Sub: Specification for Crew Voice & Video Recording System (CVVRS) along with amendment no. 1, 2 & 3.

Specification
For
Crew Voice & Video Recording System for Electric & Diesel
Locomotives

Specification no: RDSO/2015/EL/SPEC/0118, (Rev '1')
Issued on 24.10.2019

Sub: Amendment no. 01 to Specification no. RDSO/2015/EL/SPEC/0118, (Rev.01) titled as 'Crew Voice & Video Recording System for Electric & Diesel Locomotives.'

Connection Scheme of sub systems of CVVRS

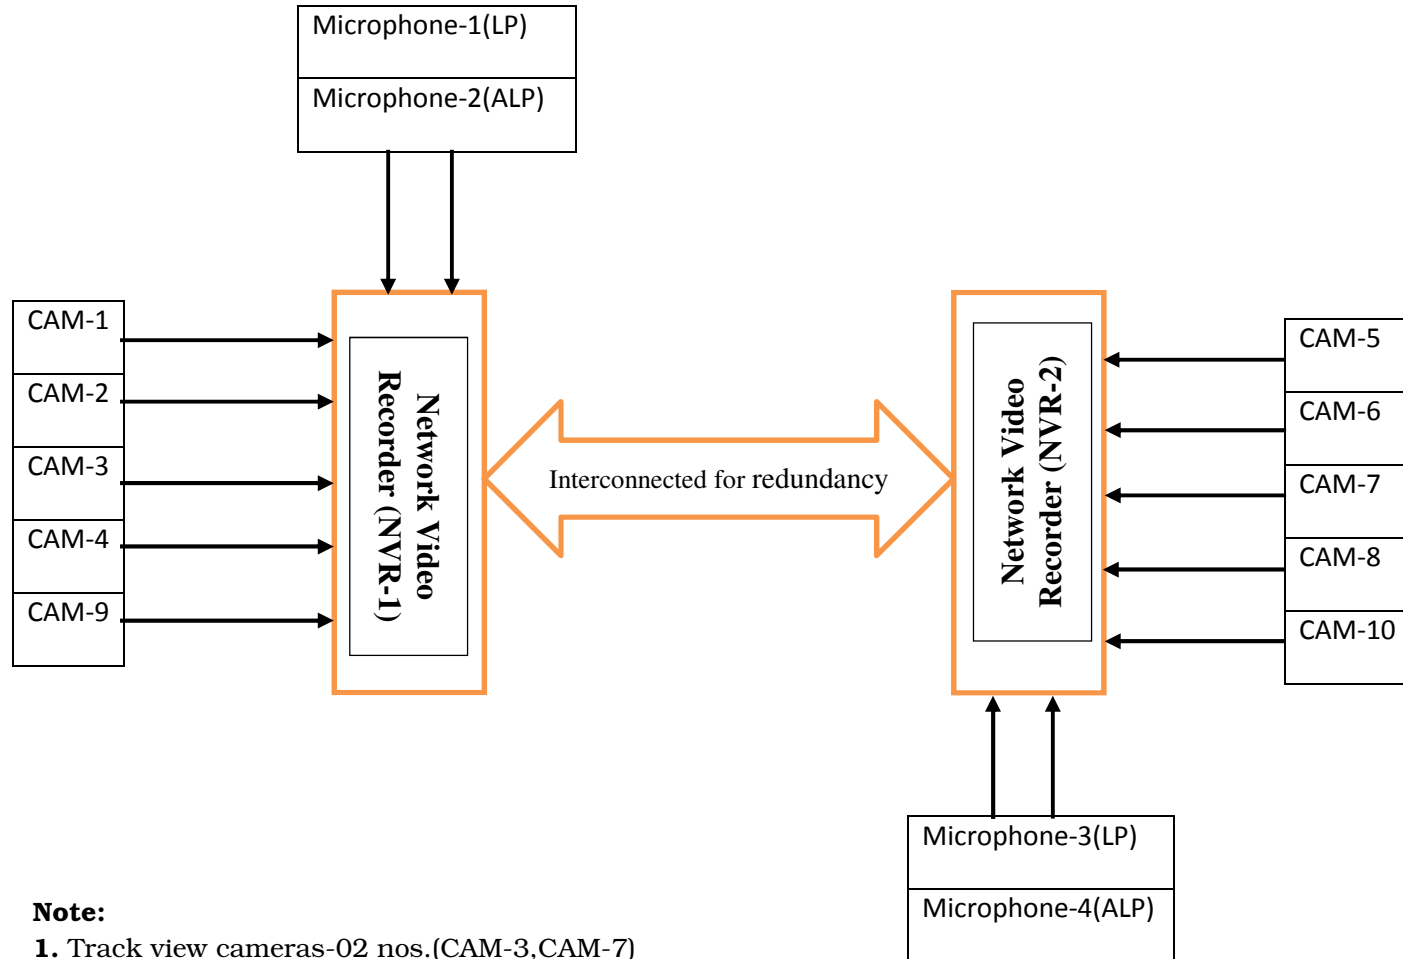
- **Clause 1.1:** Delete the text "2G/3G/" & " 2nd, 3rd & "
- **Clause 2.0: Brief Description of the Equipment**
 - The Para "Network Video Recorder.....Diesel Locomotive" should be replaced as "Network Video recorder with processing system and data storage capable of receiving standard RTSP stream from connected IP cameras & microphones. Minimum Direct 8 channel NVR shall be provided in each cab of electric Locomotive and Diesel Locomotive and both NVRs should work in redundant mode and should be capable of recording either cab. The tentative interconnection scheme of NVRs is given under Annexure-I."
 - **Add new Para in the last of the paragraph.** "• Separate flush type, screw mounted compact size microphone (02 nos.-one each in front of LP/ALP) shall be used to record the voice conversation of crews in the cab & suitably mounted on driver desk for clear voice recording."

1. Track view cameras-02 nos.(CAM-3,CAM-7)
2. Cab view cameras-04 nos.(CAM-1,CAM-2,CAM-5,CAM-6)
3. Pantograph view cameras-02 nos.(CAM-4,CAM-8)
4. Additional cameras for future expansion-02 nos.(CAM-9,CAM-10)
5. Microphones for recording LP/ALP voice-04 nos.(Microphone-1, Microphone-2, Microphone-3, Microphone-4)
